Supplementary Report

Rum Jungle Rehabilitation Project – Environmental Impact Statement

NORTHERN TERRITORY GOVERNMENT

Document title	Supplementary Report
Contact details	Department of Primary Industry and Resources
Author	J. Hartnett
Date Issued	18/06/2020

Figure 3-26 Simulated and Observed Heads for Wells RN022547, RN022548, RN023304, and MB14-17S

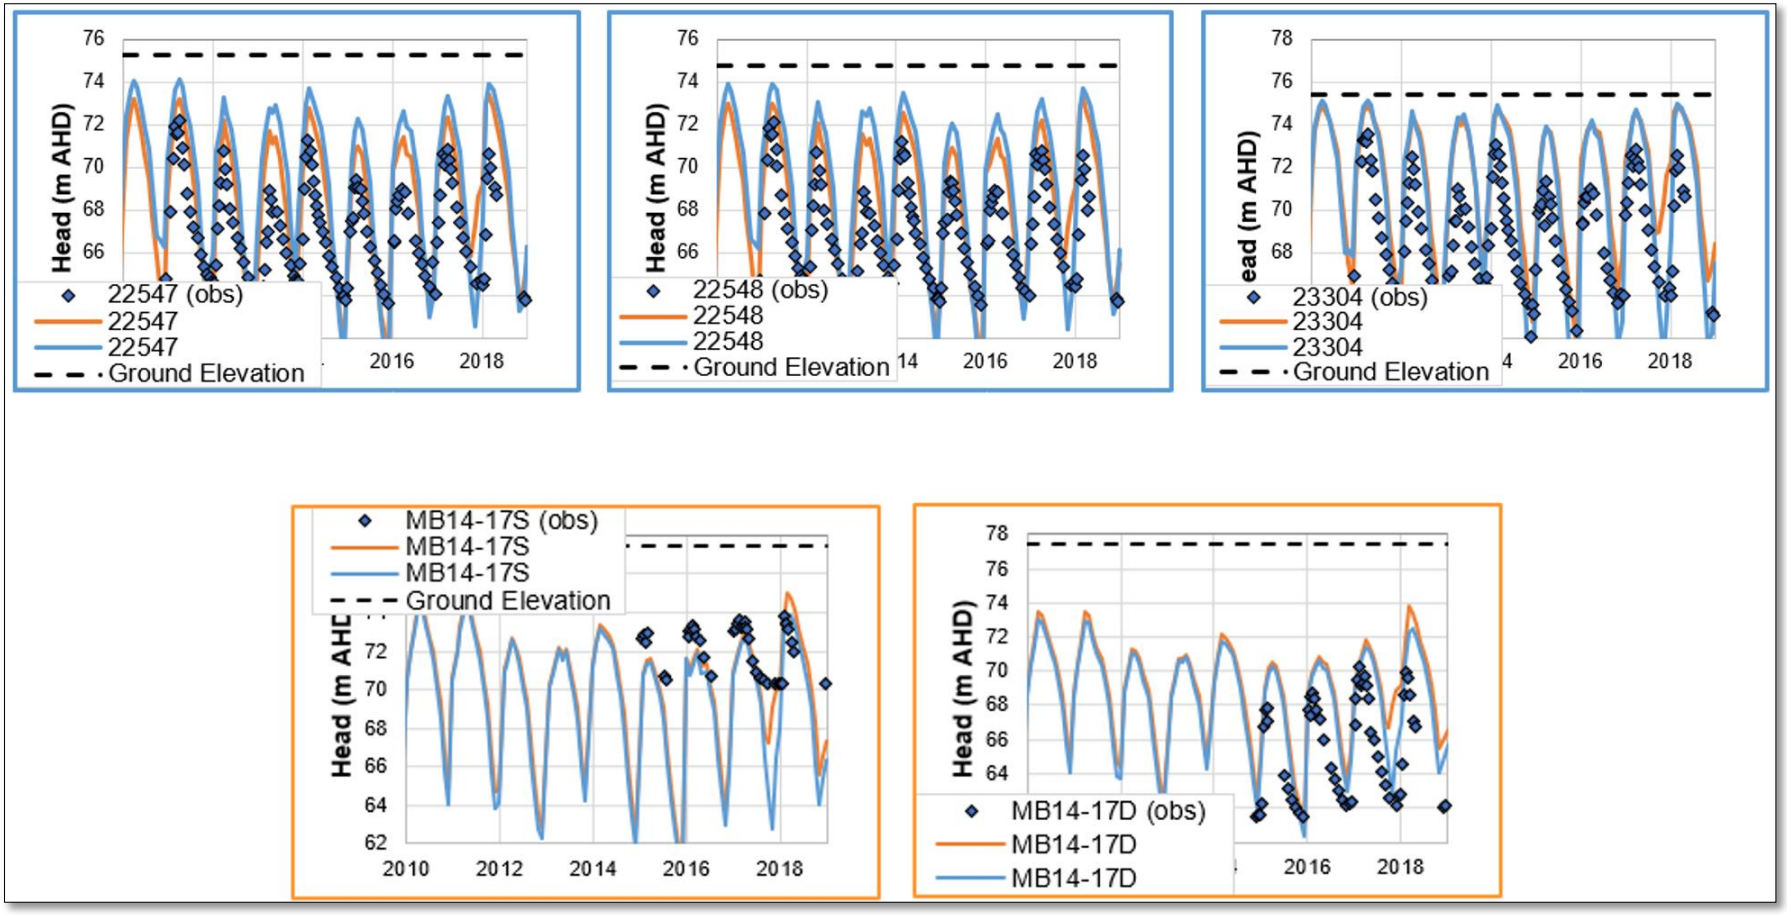
plume. The lithology map indicates this may put the plume in different geological formations. A bimodal pattern is noted in the calibration results of simulated versus observed heads (Figure 4-4). Below approximately 65 m AHD nearly all the results fit between +2 m variation. However, above 65 m the spread of data becomes much wider with many points showing a difference greater than +5 m. Given the majority of the data is for groundwater elevations below 65 m AHD this may be biasing the calibration statistics. <u>Sensitivity and uncertainty analysis</u> The Draft EIS provides a comparison between observed and modelled loads in the EBFR of Cu and SO_4. Observed and simulated loads differ up to 43% for SO_4 and up to 60% for Cu in a given water year. The results are considered a "reasonable" agreement by the author of the report, however the term "reasonable" is not defined further. The report states that the ranges of flow and transport parameters used in the sensitivity analysis are considered "plausible", however, a clear explanation of how ranges were derived is not given. Additional uncertainty analysis is recommended (e.g. as described in Middlemis and Peeters 2019). The report contains 14 recommendations to reduce model uncertainties but no indication was given in the Draft EIS if these will be implemented. <u>Model Assumptions</u> **Provide** justification for the use of the selected single dispersivity values to represent dispersivity for heterogeneous geological formations. <u>Differences between observed and modelled current conditions</u> **Provide** clarification of differences between observed and modelled current conditions, including: • an explanation for the discrepancy in plume locations and whether this may have implications for the predicted contaminant transport. • an explanation of the bimodality in the calibration data as well as separate calibration statistics above and below 65 m AHD. <u>Sensitivity and uncertainty analysis</u> **Provide** • an explanation for the choice of parameter ranges used in sensitivity analyses

The simulated heads by the calibrated flow model match the seasonal variations observed at these bores reasonably well (Figure 3-26). However, observed discrepancies, particularly at the highest and lowest values, suggest local aquifer heterogeneity and/or variability in response to local stresses such as evapotranspiration which are not accounted for in the model. These small differences for these four wells (and hence the bimodality in heads) is not a significant source of uncertainty in the model, so Robertson GeoConsultants did not exclude them from the model calibration.
